Memorandum

TO: Columbia River Crossing Task Force
FROM: CRC Pedestrian and Bicycle Advisory Committee (PBAC)
SUBJECT: PBAC Recommendations for World Class Pedestrian and Bicycle Facilities

Purpose of this Memorandum

PBAC Proposed Pedestrian and Bicycle System for Replacement Bridge

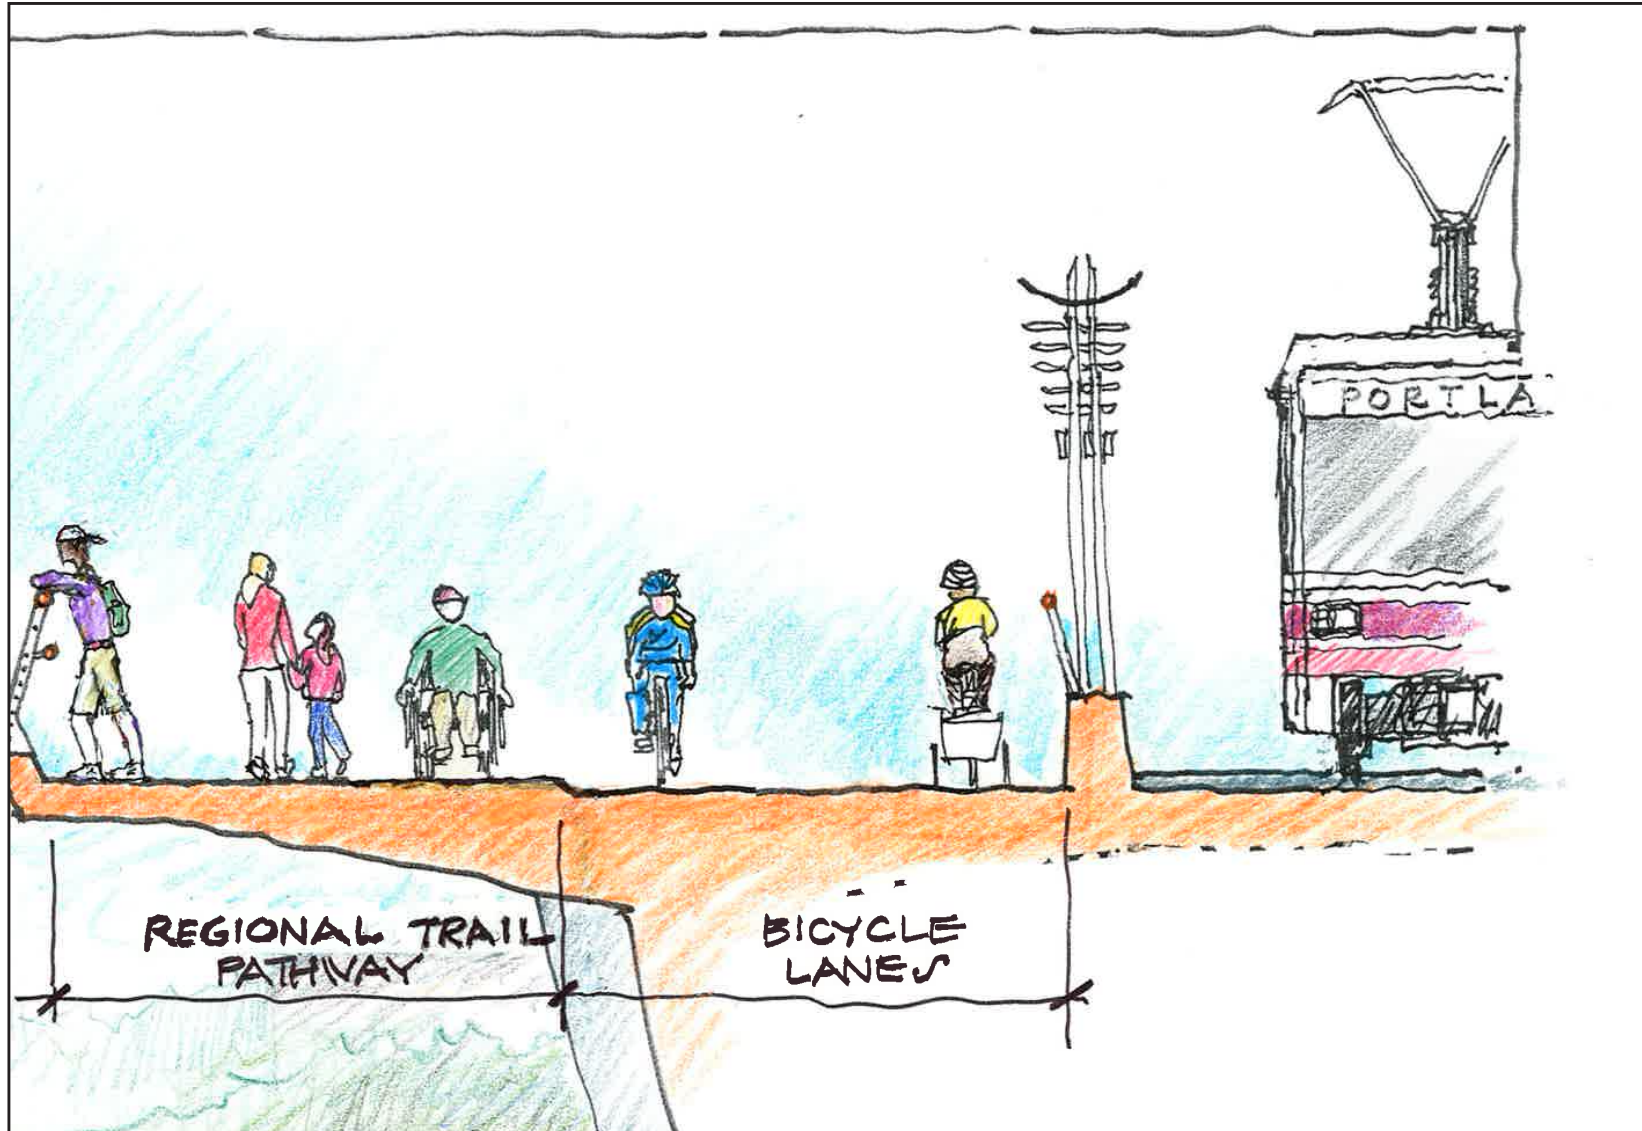
- The overall pathway on the western bridge (adjacent to the transit guideway) must provide separation between recreational users and higher speed bicycle users. To provide this separation, a 12-foot wide regional trail should be provided adjacent to, and to the west of, a pair of six-foot wide bicycle lanes (see attached rendering). These recommended widths are exclusive of potentially needed shy distances, i.e., free and clear of poles and other obstructions to enable safe pedestrian and bicycle movement (a summary of agency standards for multiuse paths, sidewalks and bike lanes is attached).

- In addition to the combined regional trail and bicycle lanes on the western bridge, an eight-foot wide sidewalk should be provided on the eastern bridge (the bridge that would serve the northbound traffic lanes) across both the Columbia River and the North Portland Harbor. The sidewalk across the North Portland Harbor would touch down on Hayden Island and use surface street sidewalks to connect to the sidewalk across the Columbia River.

- Additional access points, discussed as possibilities in the Draft EIS, should be provided to make the river crossing paths connect more directly to parks and recreational trails. Some examples of these facilities are the Columbia River Waterfront Trail in Vancouver, the river adjacent areas on Hayden Island, and the 40 Mile Loop in Oregon.
- Viewpoints or "belvederes" should be provided at locations along both the regional trail on the western bridge and the sidewalk on the eastern bridge. These features would also function as rest areas for pathway users.

Pedestrian and Bicycle Advisory Committee Recommended Pathway on West Side of West Replacement Bridge (Looking North)

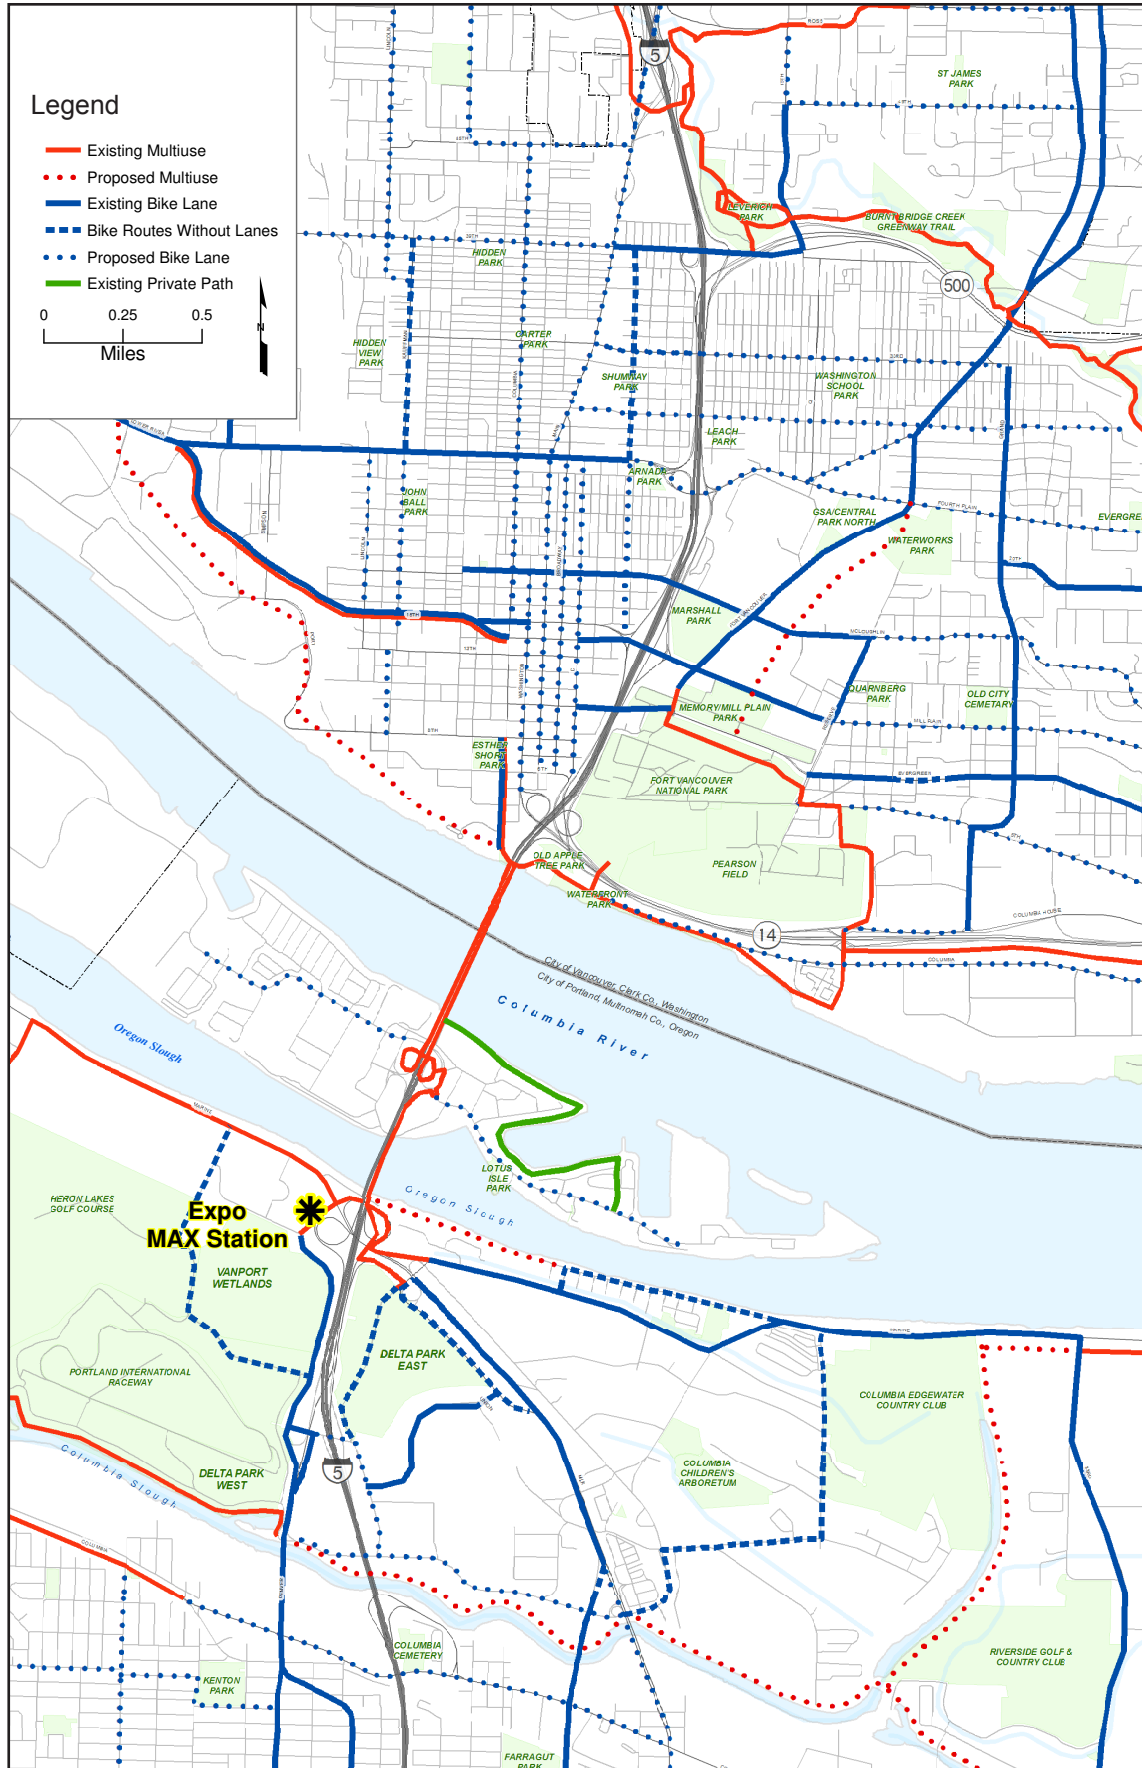
The regional trail would accommodate pedestrians, persons with disabilities, seniors, families with children, tourists, roller-skaters, and recreational bicycle riders. The adjacent bicycle lanes would be used by bicycle commuters and other faster-moving bicyclists. The regional trail would be at a slightly higher level than the bicycle lanes, but bicyclists in the bicycle lanes would be able to access the trail. Different paving treatments and/or patterns should differentiate the regional trail and the bicycle lanes.
